Environmental Review Team Report

Industrial Roadway

Deep River, Connecticut

August 1984

Topography

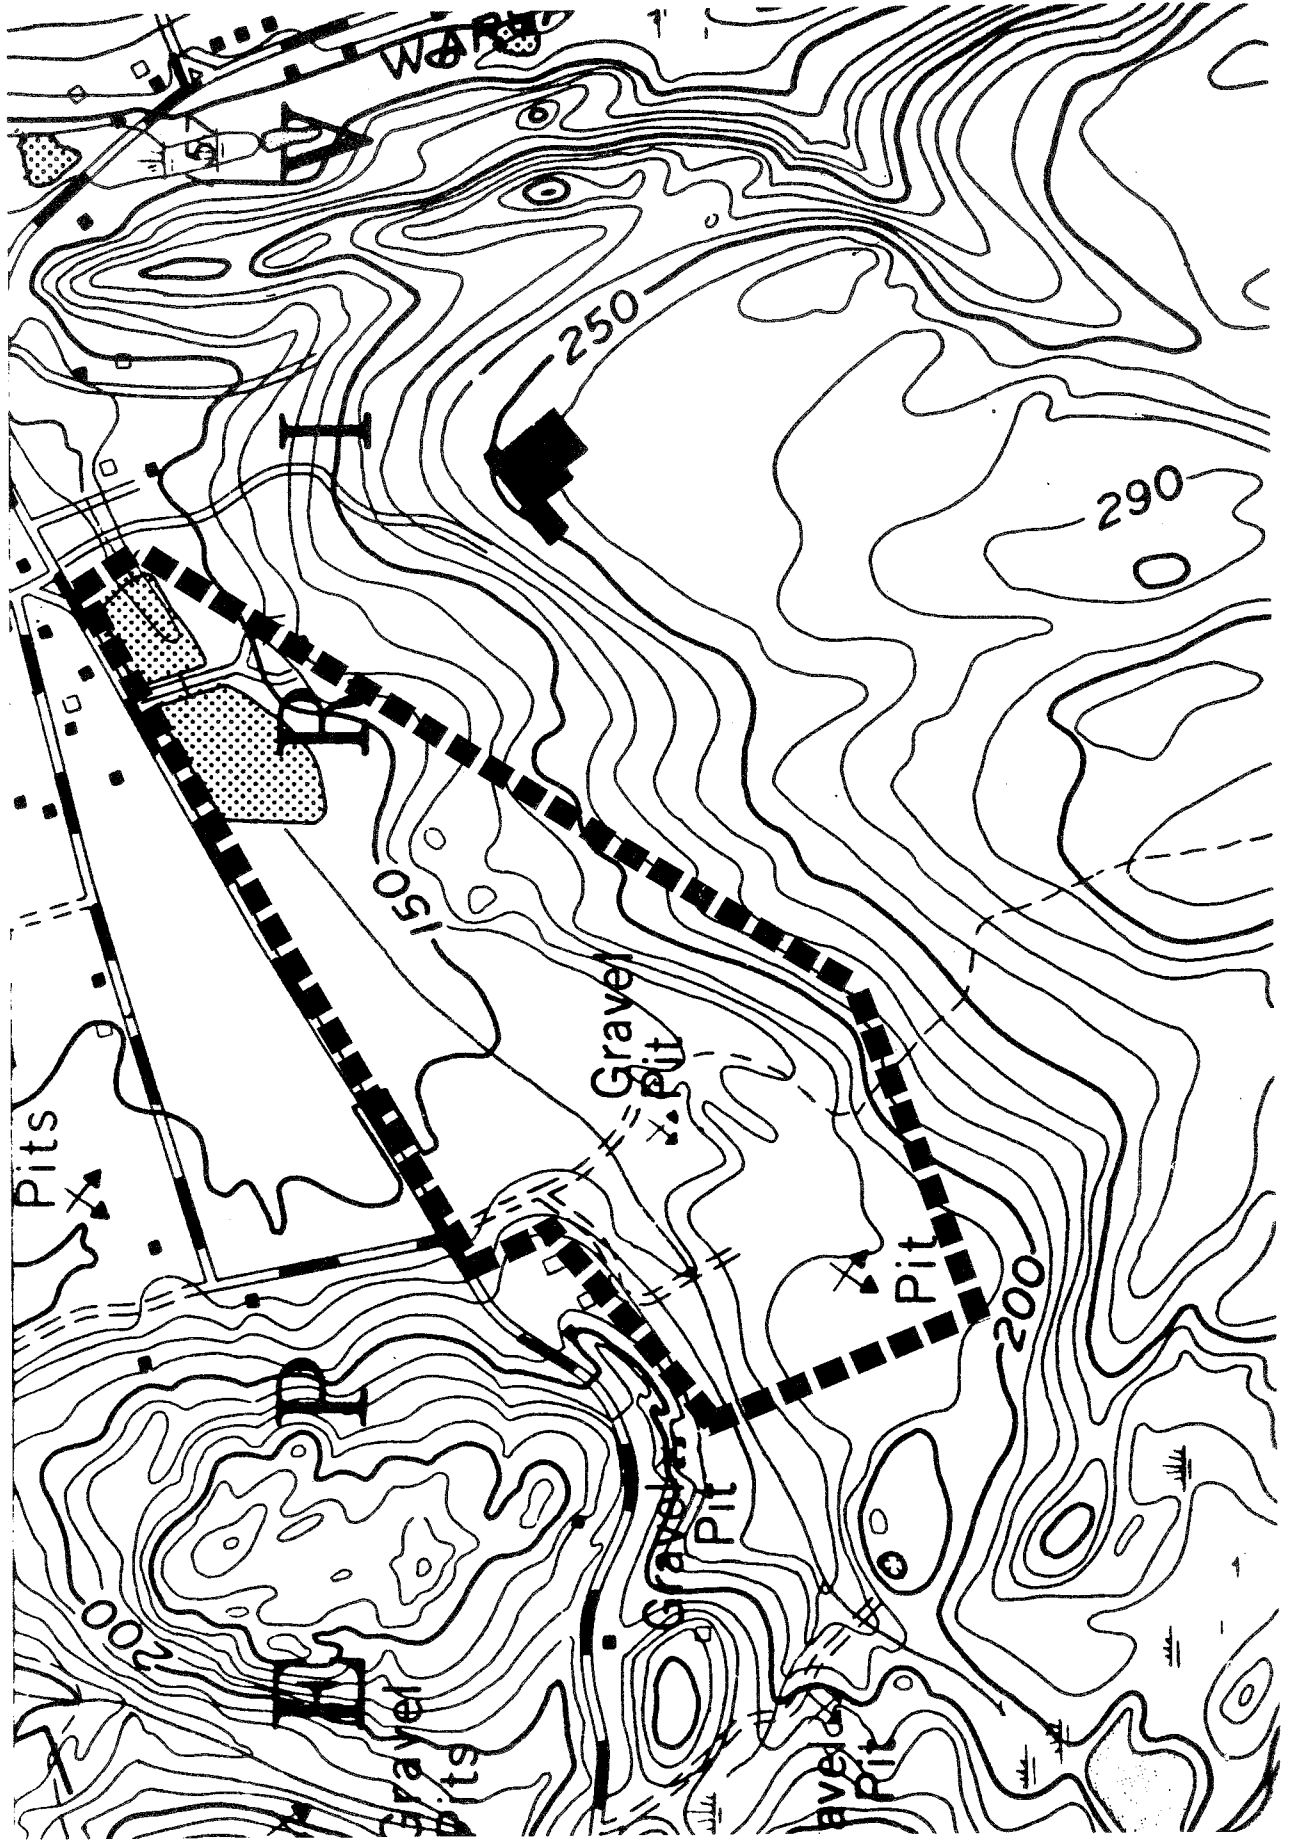
Slopes in the study area are relatively flat. They rise moderately from the existing access road into the site which is shown on the accompanying topographic map, westward to the top of a bedrock controlled knob. Maximum and minimum elevations in the study area are about 150 feet and 170 feet above mean sea level.

Surficial Geology

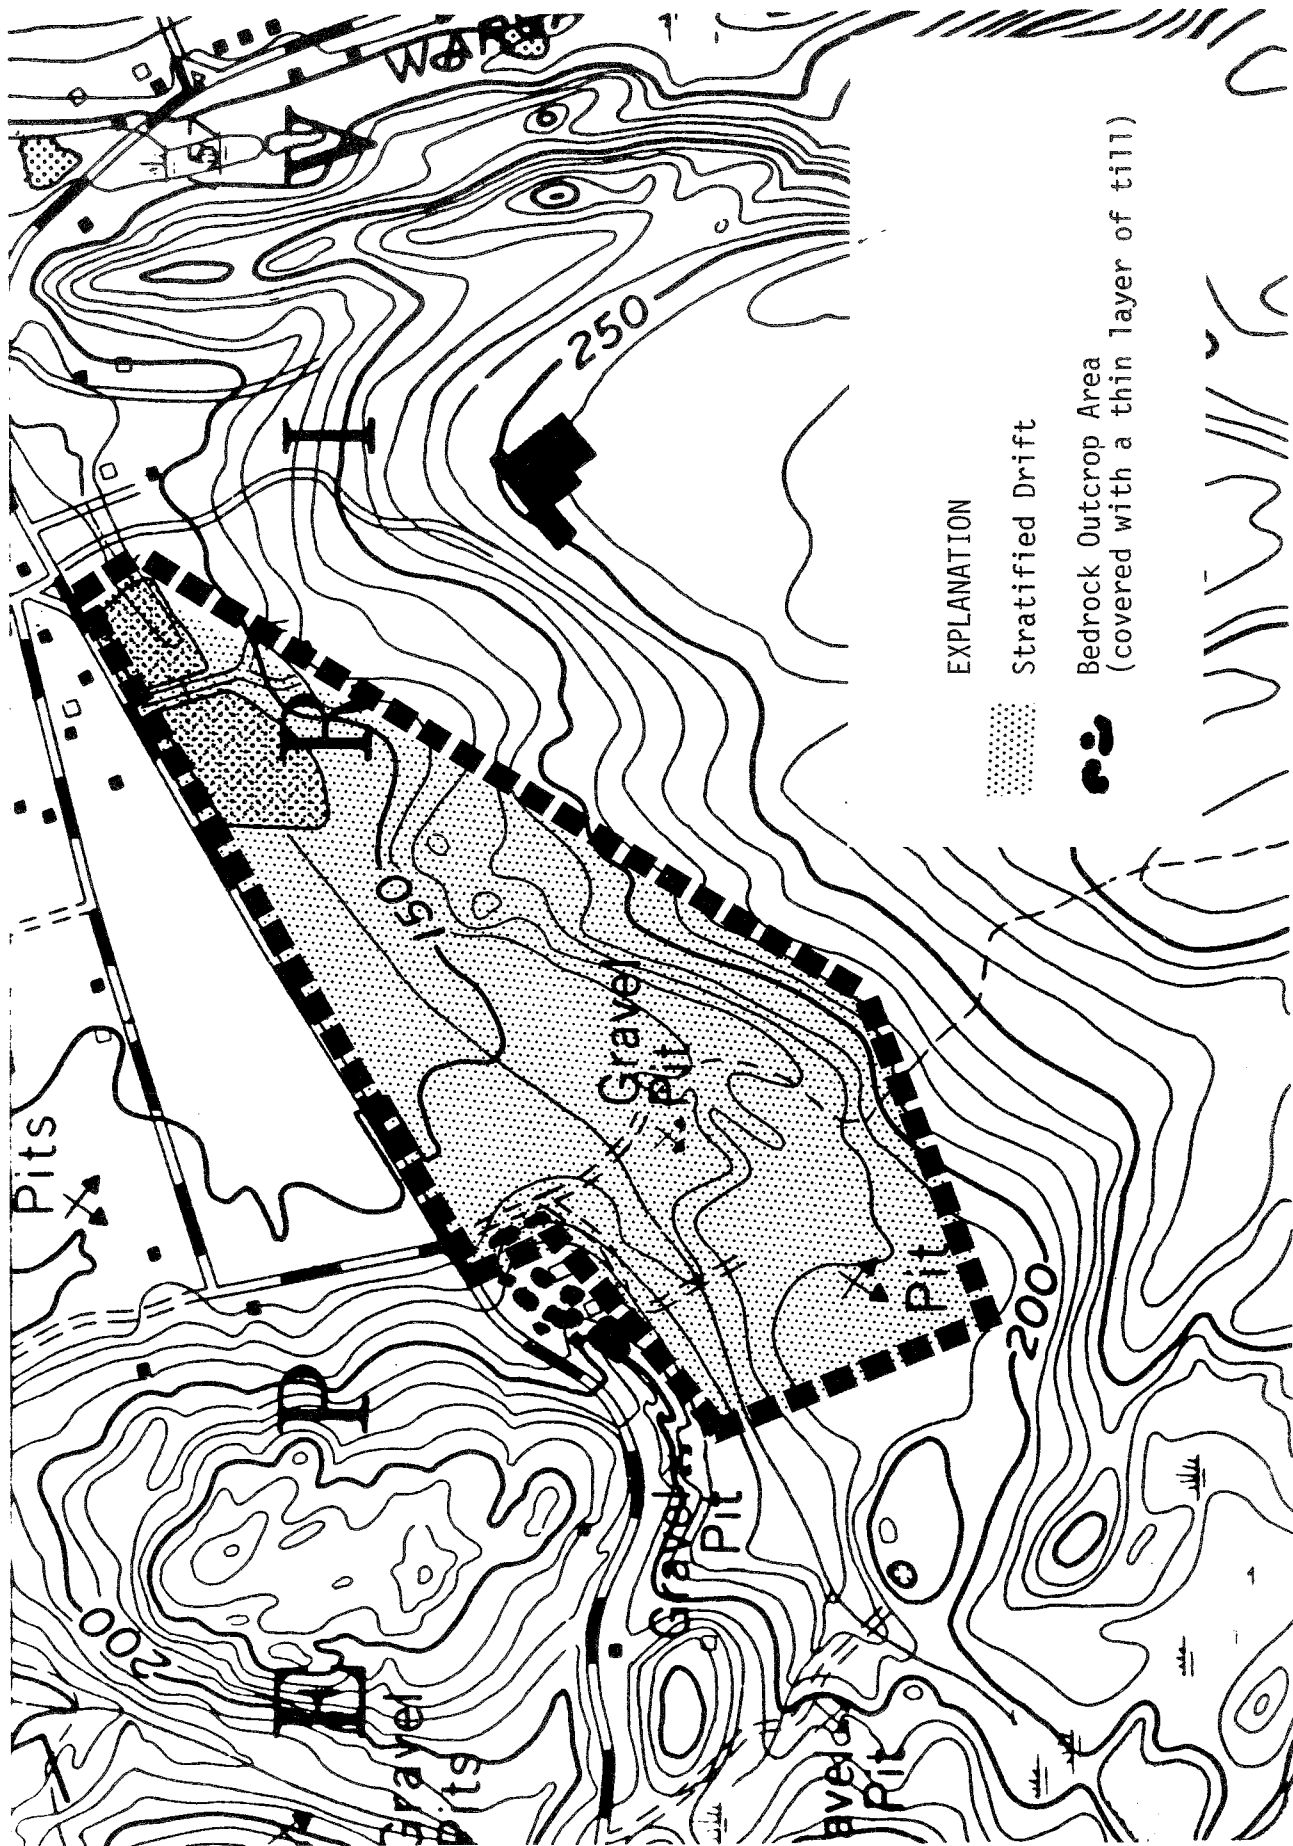
The study area is covered by sediments that were deposited by glacial melt-water streams. These sediments are referred to as stratified drift. The predominant components of the stratified drift are sand and gravel, but there may be some silt and clay layers. Stratified drift is commonly layered (stratified) and ranges from poorly to well-sorted. The exact thickness of the stratified drift in the study area is unknown, since much of the sand and gravel has been mined in these areas. Bedrock visible along the existing road suggests that they are probably relatively thin (not more than 10'). If bedrock is encountered, there is a chance that blasting may be required in order to construct the road.

West of the existing road, which leads into the Connecticut Valley Sand and Gravel operation, the stratified drift grades into an area of shallow bedrock. The bedrock is covered by a relatively thin blanket of till. Till, like stratified drift is a glacial sediment. However, because the till was deposited directly from an ice sheet, it lacks the sorting (the separation of grain sizes) and the layering that is characteristic of stratified drift.

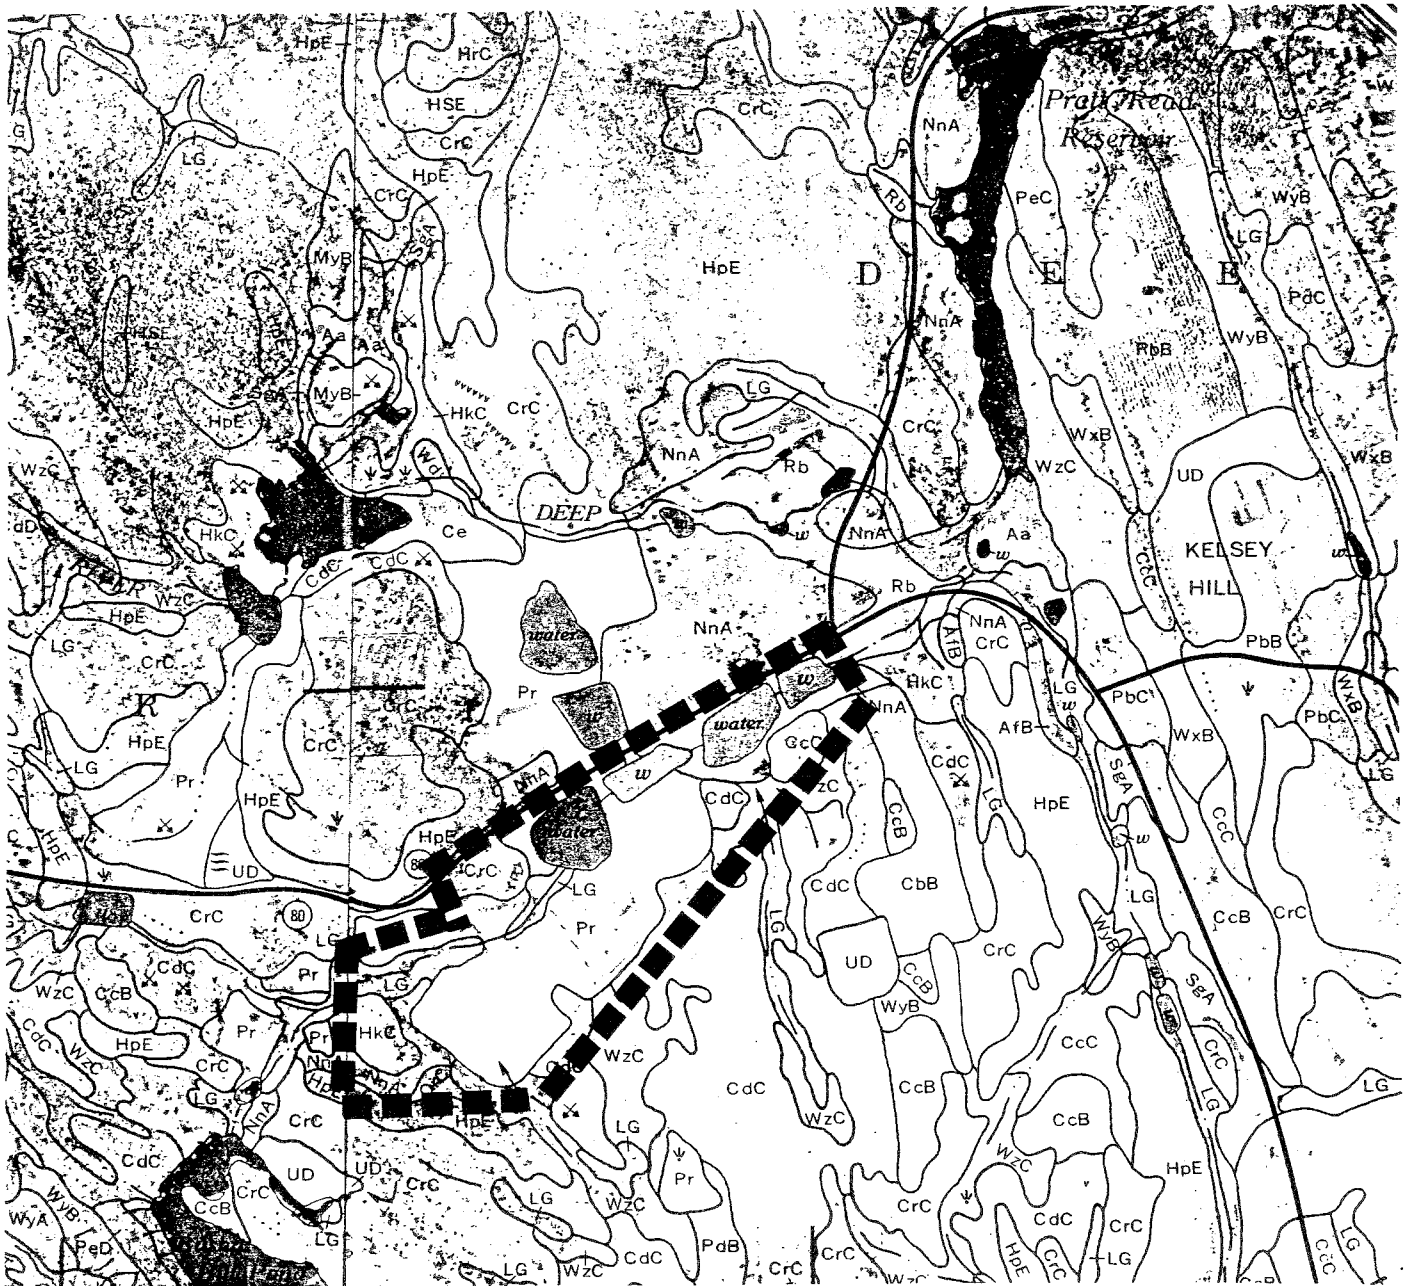
Another area of possible consequence to the swimming pond is where the proposed access road is to cross the corner of the pond and connect to Route 80. Runoff from Route 80 collects in an adjacent road ditch which outlets into the pond in several locations. In most cases these outlets are eroded, and sediment and road salts are entering the pond. This problem needs to be addressed in the final plan.

One corner of the pond will have to be filled for the construction of the access road, and this may present a severe impact to the pond. The soils in this area are very erosive and unstable. This corner of the pond is quite deep, with steep side slopes. It is prone to sloughing. Filling in this area for heavy loads needs to be carefully studied, for it too will be subject to sloughing and unstable conditions.
